<b>Docket Number:</b>	21-AFC-02
<b>Project Title:</b>	Willow Rock Energy Storage Center
<b>TN #:</b>	259675
<b>Document Title:</b>	Willow Rock Data Request Set 3 Response
<b>Description:</b>	N/A
<b>Filer:</b>	Kathryn Stevens
<b>Organization:</b>	WSP USA Inc.
<b>Submitter Role:</b>	Applicant Consultant
<b>Submission Date:</b>	10/23/2024 4:55:23 PM
<b>Docketed Date:</b>	10/23/2024

**Willow Rock Energy Storage Center (21-AFC-02)**  
*Data Request Response Set 3*

**GEM A-CAES LLC**

**Figure DR77-1: Drill Shaft Profile**

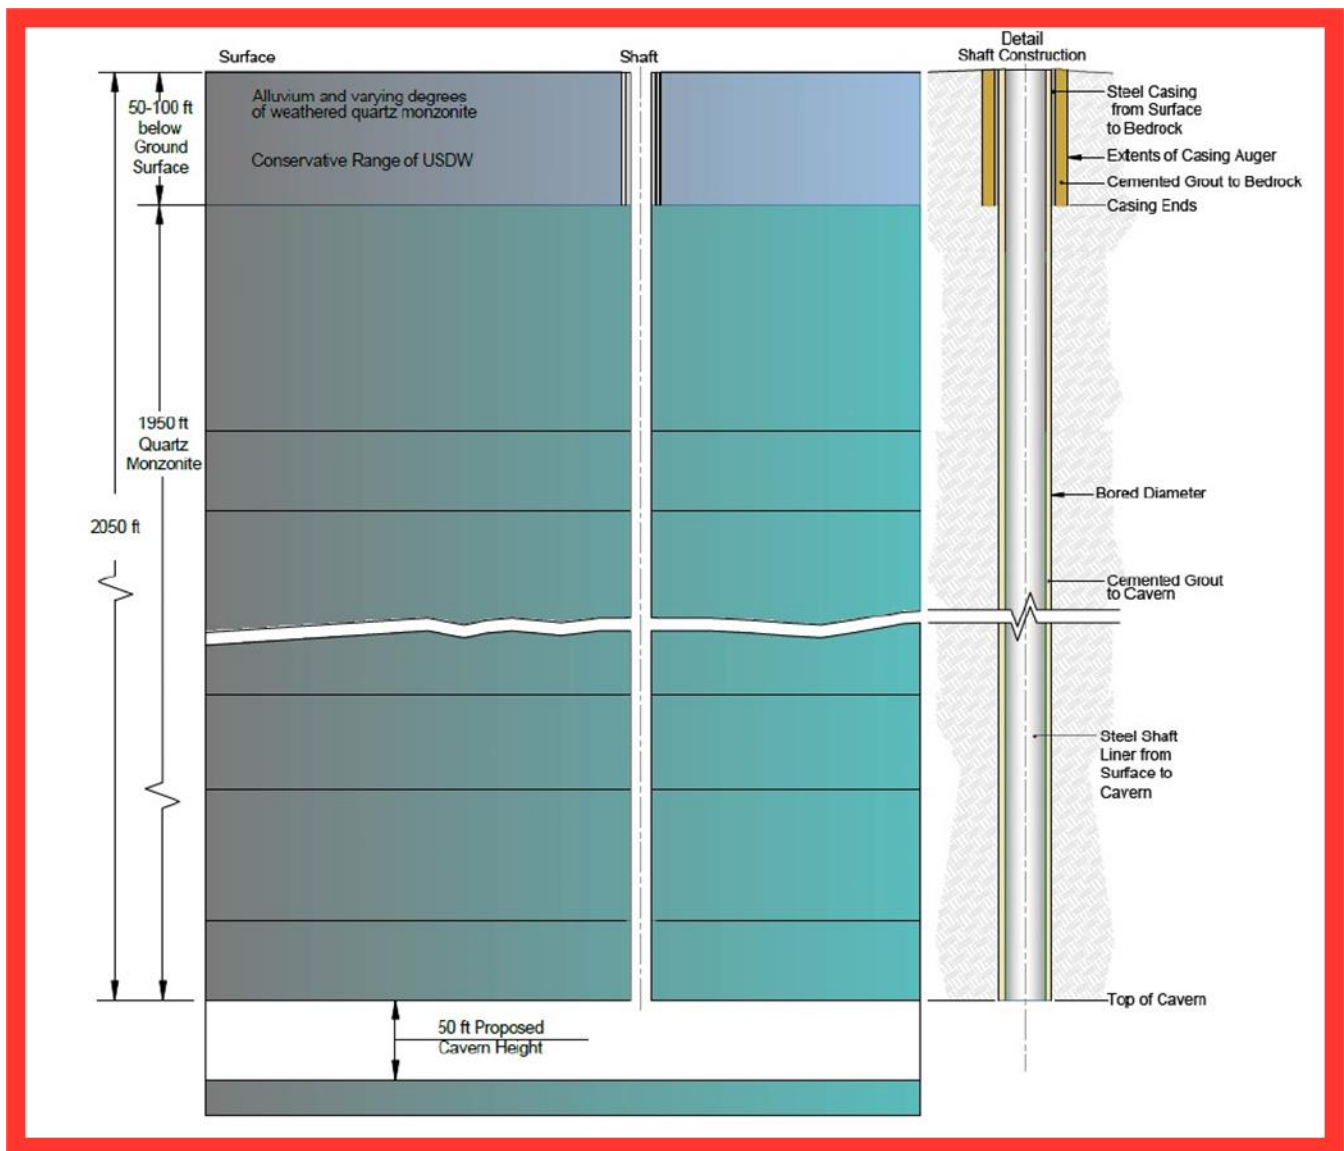
**DR77:** Please explain how the access will be provided to the shaft drilling which begins at 50-100 feet bgs by providing a discussion, and a vertical drawing plot plan.

**Response:** Hydrostor is planning on constructing shafts at the project site utilizing a blind-boring/drilling approach. This method is an efficient and cost-effective way to construct the shafts, where mechanized excavating equipment is positioned at the top of competent bedrock and drilling proceeds vertically downwards. The excavating equipment consists of a blind boring shaft drilling rig, from which a drilling head is suspended utilizing drill rods. As the drilling head incrementally reams downward into the subsurface geology, additional drill rods will be added to further advance the cutting head assembly. As shown in **Figure DR77-1** below, each shaft will be approximately 8 feet in finished internal diameter.

Each shaft will receive a surface casing, extending down to competent bedrock, prior to the start of the blind-boring process. The purpose of the surface casing will be to prevent unconsolidated soils and weathered rocks from unraveling into the shaft, as well as prevent any communication between the shallow aquifer and shaft. The depth to competent bedrock is currently assumed to be approximately 40 to 50 feet from the surface. For each 8-foot diameter shaft, an 11.5-foot diameter hole will be created to install surface casing using a specialized auger drill. The surface steel casing will be 0.5 inches thick at the minimum. The surface casing will be installed inside a mechanically excavated hole. The excavation and surface casing installation will be concurrently performed using a combination of a specialized auger drill and a large vibratory hammer to advance the casing through the upper soft ground down to bedrock. The annular space between the surface casing and the augered hole will be tremie-backfilled with cementitious grout to stabilize the surface casing into position while sealing casing-hole interface from any future fluid migration. The figure below shows the general profile of a blind bored shaft from the surface to the subsurface cavern level, including the steel surface casing that will extend down to the competent bedrock.

**Response:** The roof of the cavern will be approximately 2,050 feet bgs (Refer to Figure above), meaning that at least a 1,950-foot thick massive Quartz Monzonite rock mass will exist between the cavern roof and the bottom of soils zone at the site.

PROJECT NO.	PHASE	REV.	FIGURE
US0029687.4225	100	0	DR44-1

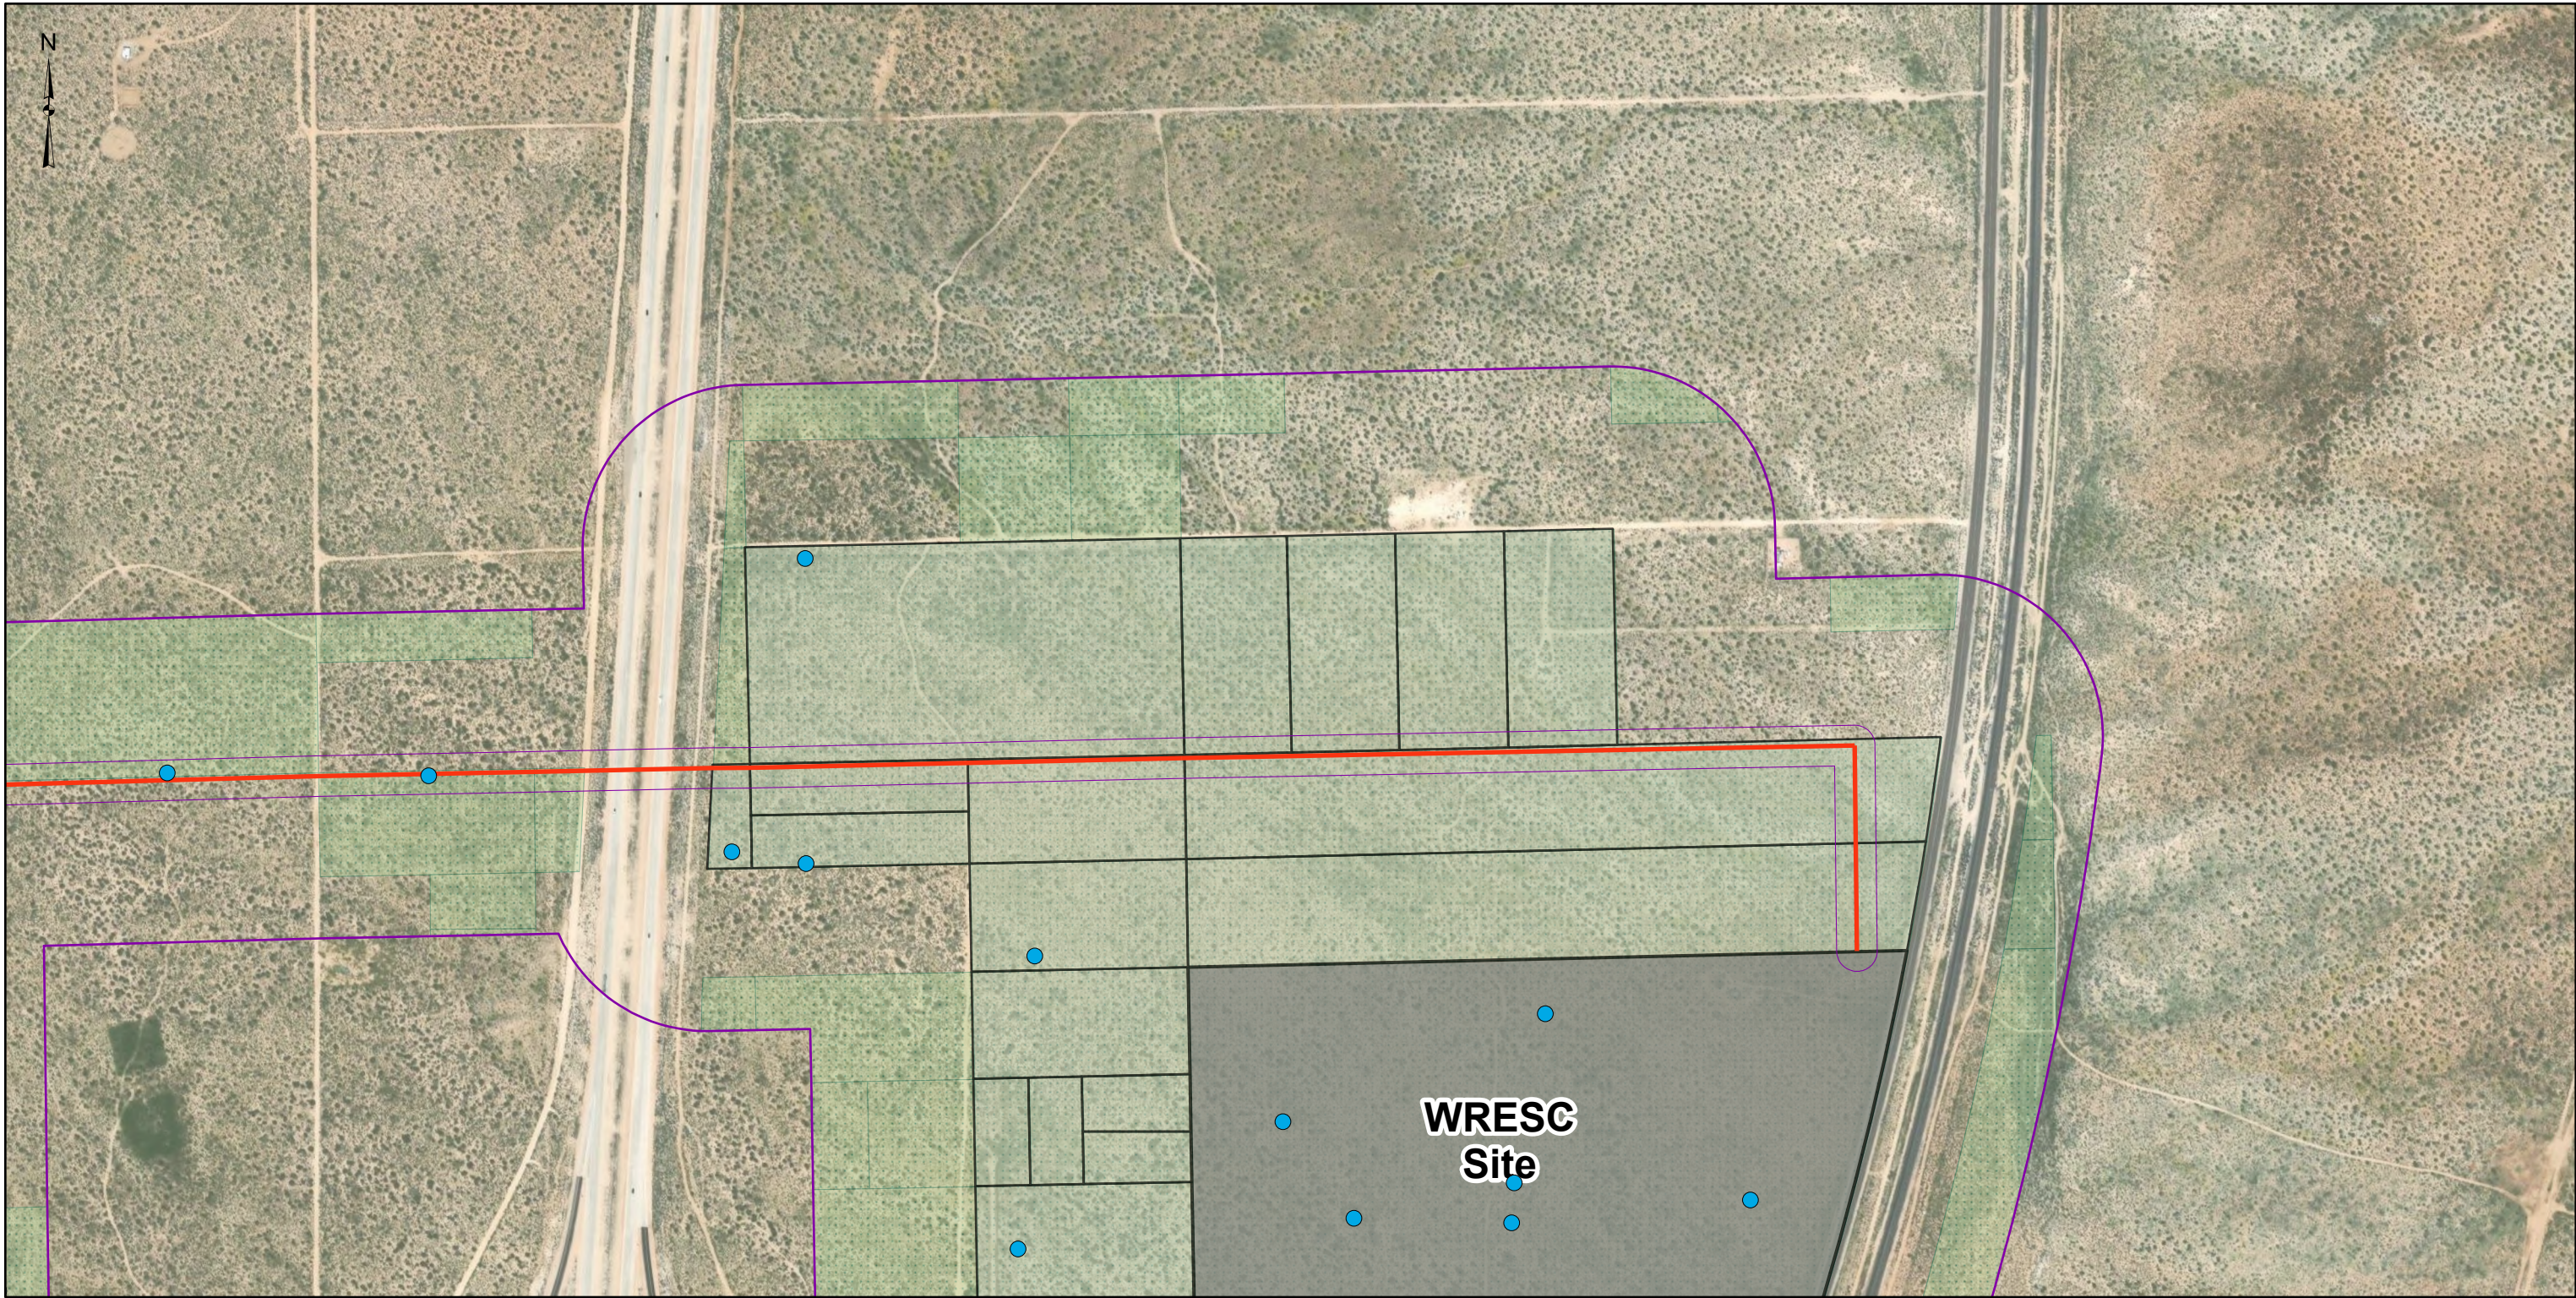
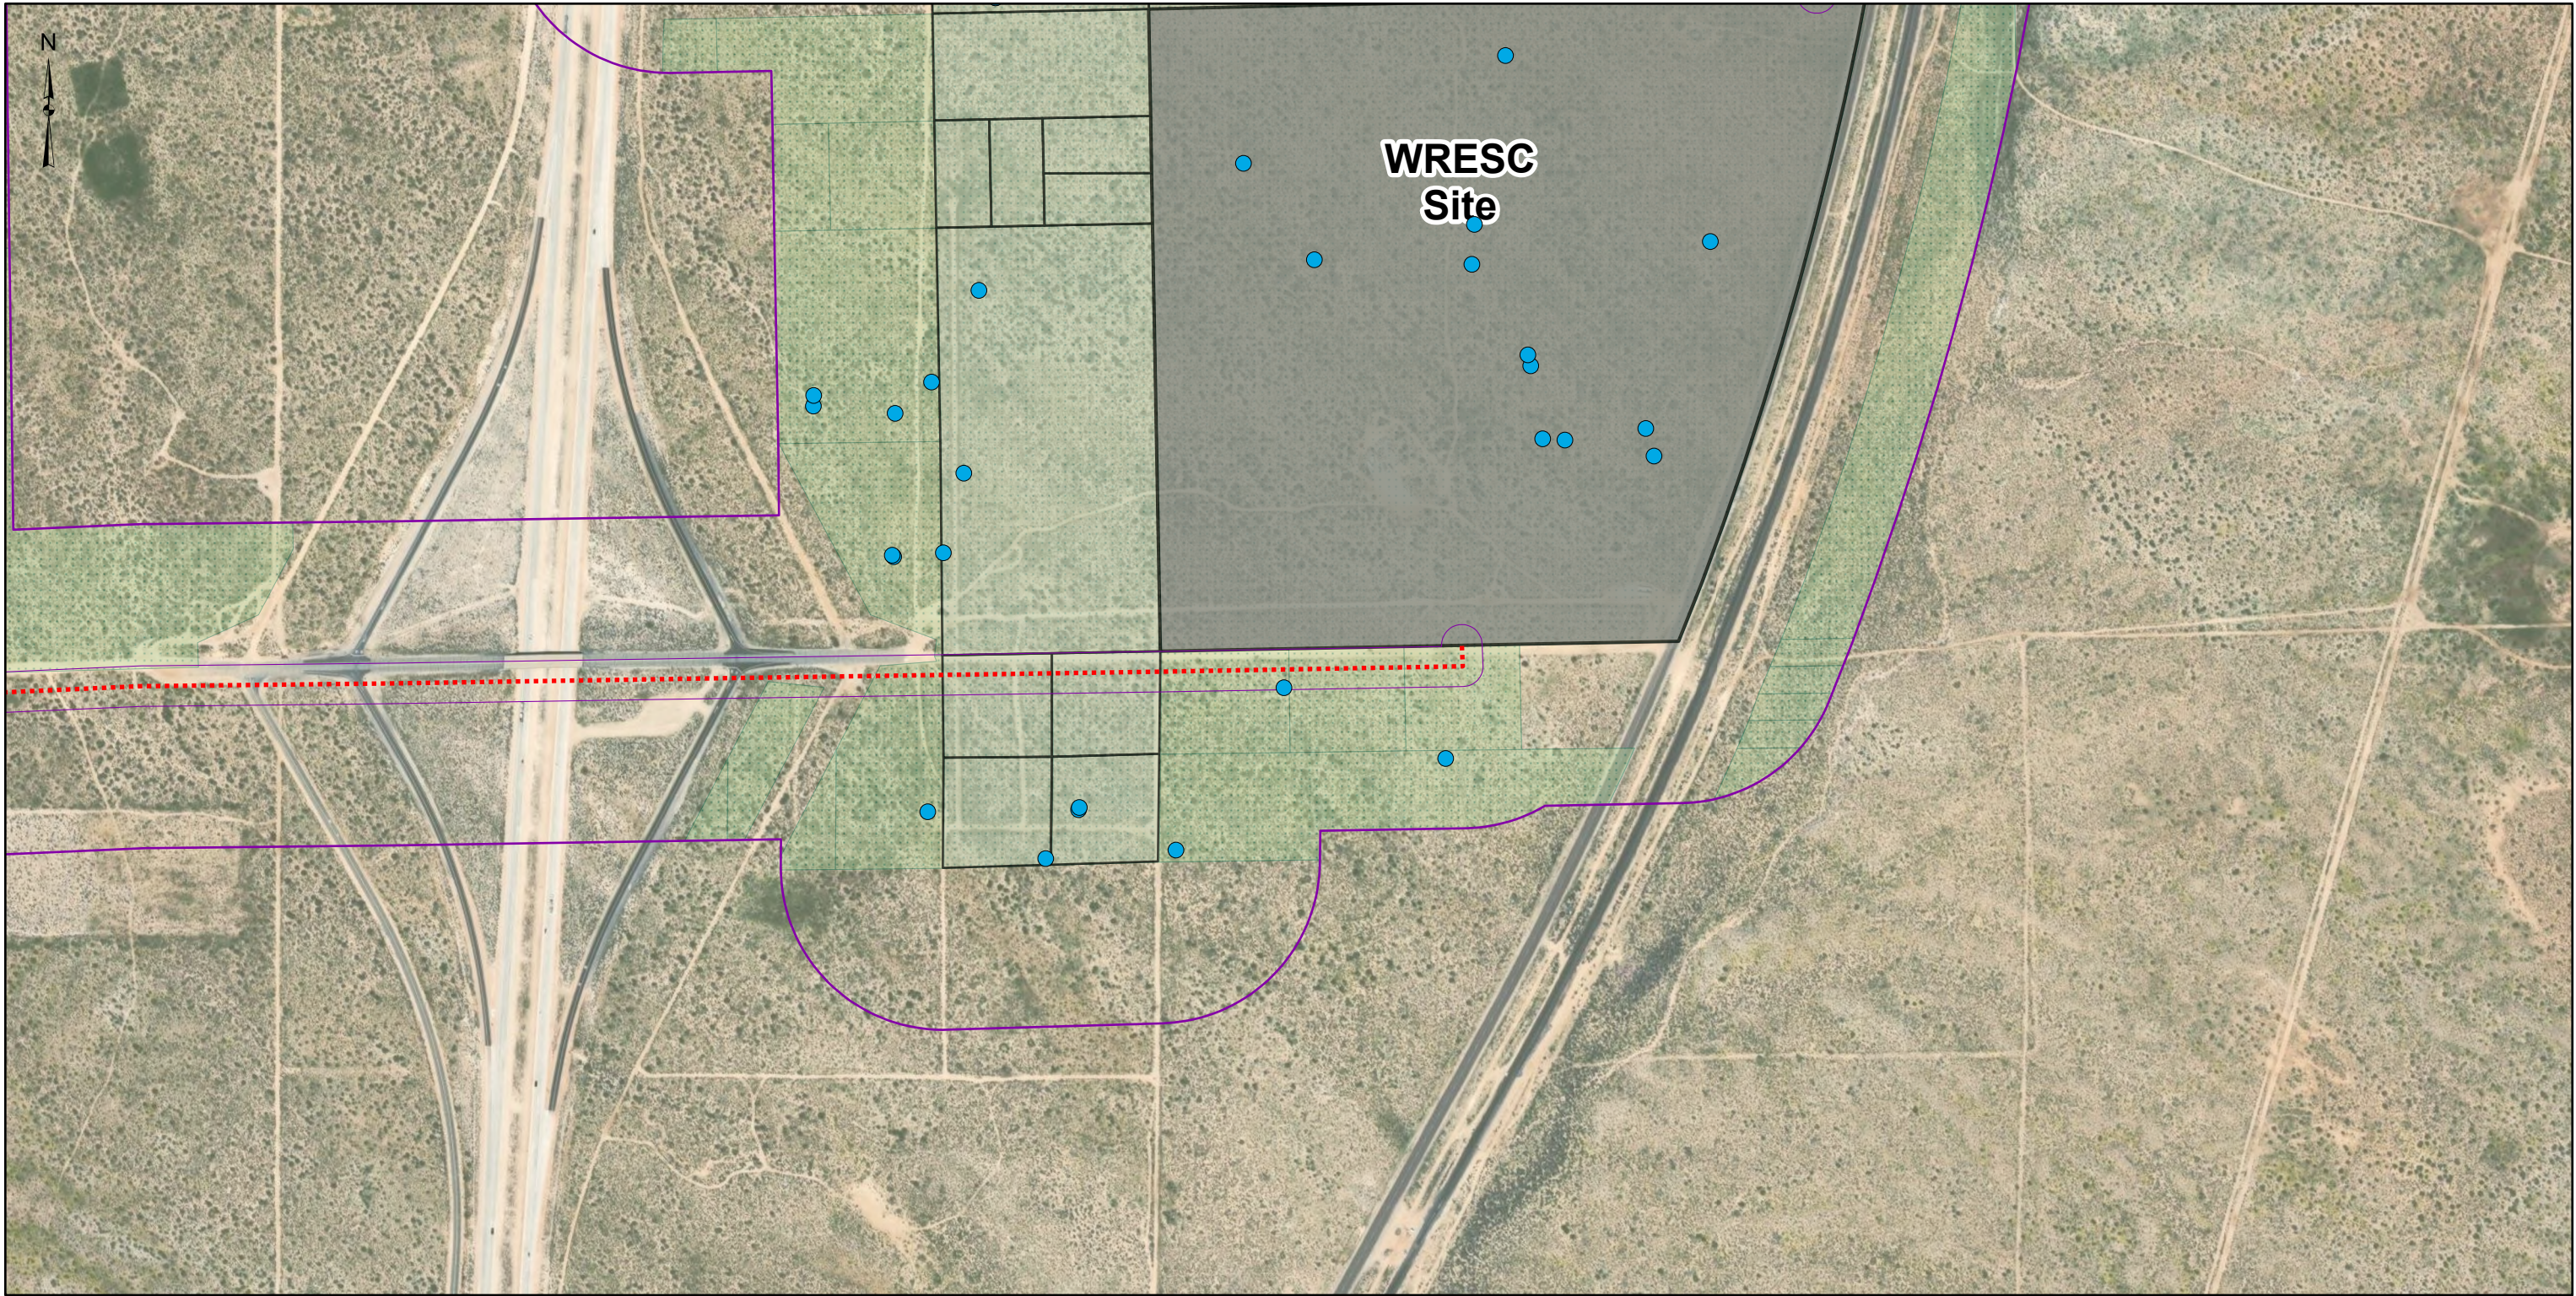
**DR44:** Please provide a map of the location(s) of silver cholla found within all areas of the project (e.g., project site, gen-tie, staging, parking, etc.) including (to the extent feasible) within a 500-foot buffer from the areas that will be impacted by the project.

**Response:** See **Attachment DR44-1** for a map of the locations of silver cholla observations found in all areas of the project within a 500-foot buffer.
